# Rezoning Transportation Analysis

Petition Number: 2019-036

General Location Identifier: 05301131

Date	Description
04-15-2019	First Review

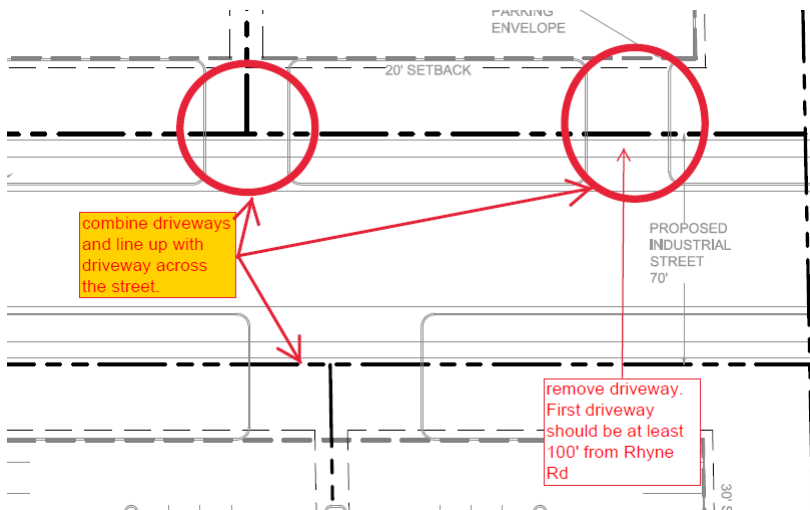
- Curbline** The future back of curb to be placed 29.5' from the centerline of Rhyne Road. The ultimate cross section should include an 11' left turn lane from Rhyne Road onto the proposed Industrial Street, one travel lane, 5' bike lane, 2'-6" curb and gutter, 8' planting strip and 6' sidewalk.
- Traffic Study** A Traffic Impact Study is not necessary for the complete review of this petition.
- Per Chapter 19 ordinance, the petitioner should revise the site plan and conditional note(s) to commit to the construction of curb and gutter, 8' planting strip and 6' sidewalk along the property frontage of Rhyne Road.

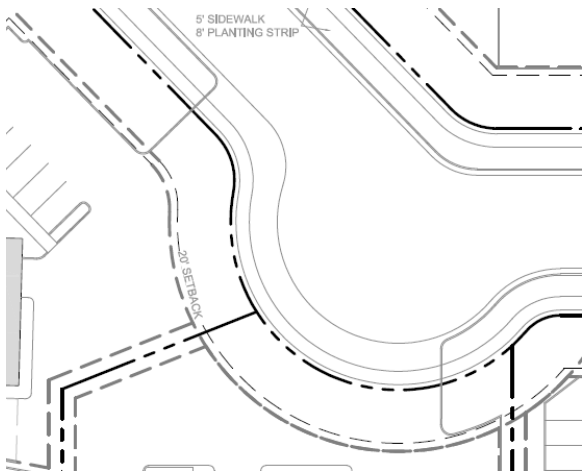
7. The petitioner should revise the site plan to eliminate the driveway shown below to reduce vehicular conflict points.
  - a. The petitioner should revise the site plan to combine the driveways and line them up adjacent from one another along the Proposed Industrial Street to eliminate multiple conflict points.
